ROLAND DG CORPORATION / SERVICE DEPT.

**MDX-650**

**Spindle lock and Abnormal noise  
(Change in Flange shape)**

**PARTS:**

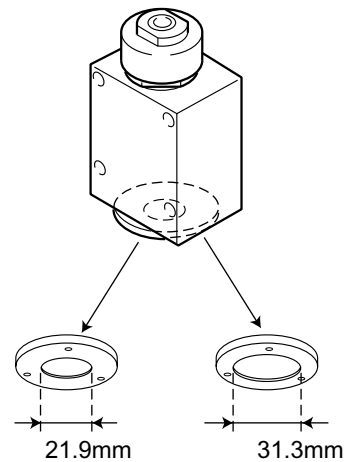
Little milled dust has stuck to the spindle and melted in the heat of the rotating spindle and then flew to the bearing.

The bore diameter of the flange has been changed to prevent milled dust from collecting between the flange and the spindle.

Parts No. 21995116-01

Parts Name: FLANGE, SPINDLE(T) ZS-500T

We will supply only the new parts.
